**DEPARTMENT OF TRANSPORTATION**

Contract #: 04-0120F4Cty: SF/ALA Rte: 80 PM: 13.2/13.9File #: 69.28**WELDING INSPECTION REPORT****Resident Engineer:** Pursell, Gary**Address:** 333 Burma Road**City:** Oakland, CA 94607**Report No:** WIR-007866**Date Inspected:** 30-Jun-2009**Project Name:** SAS Superstructure**OSM Arrival Time:** 645**Prime Contractor:** American Bridge/Fluor Enterprises, a JV**OSM Departure Time:** 1700**Contractor:** Zhenhua Port Machinery Company, Ltd (ZPMC), Changxing Island **Location:** Shanghai, China**CWI Name:** Li Yan Hua**CWI Present:** Yes No**Inspected CWI report:** Yes No N/A**Rod Oven in Use:** Yes No N/A**Electrode to specification:** Yes No N/A**Weld Procedures Followed:** Yes No N/A**Qualified Welders:** Yes No N/A**Verified Joint Fit-up:** Yes No N/A**Approved Drawings:** Yes No N/A**Approved WPS:** Yes No N/A**Delayed / Cancelled:** Yes No N/A**Bridge No:** 34-0006**Component:** OBG Assembly**Summary of Items Observed:**

Trial Assembly Yard

Segment 6CE

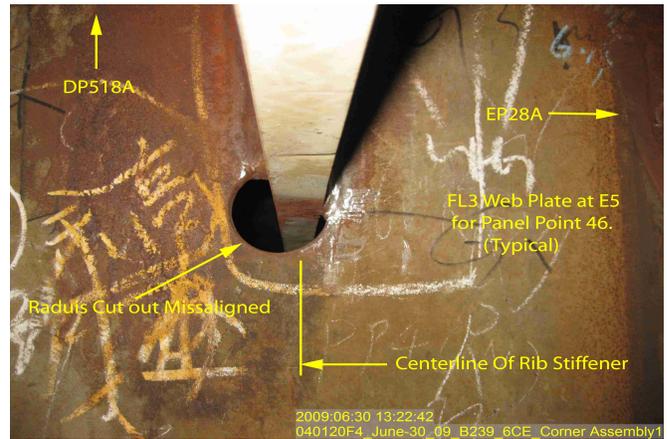
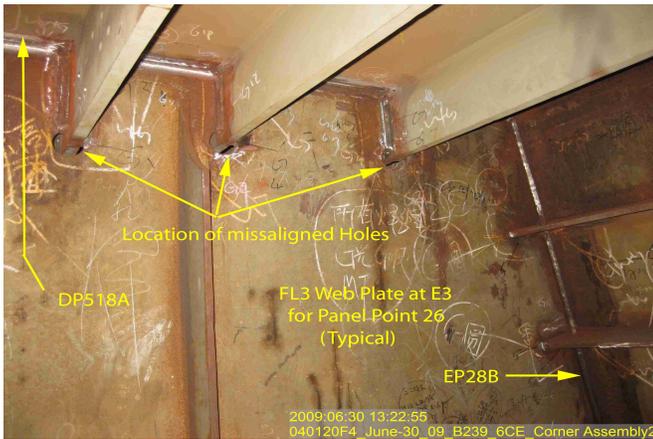
During random in process visual inspection of the internal components of Segment 6CE, Caltrans Quality Assurance (QA) Inspector discovered that the radius cut outs in the floor beam web plate, for deck panel 518A rib stiffener penetrations, were misaligned in way of E5 at the following panel points; 44, 45, 46, 46.5 and 47. A total of (11) eleven locations were noted with the fabrication issue as mentioned above. See incident report for this date.
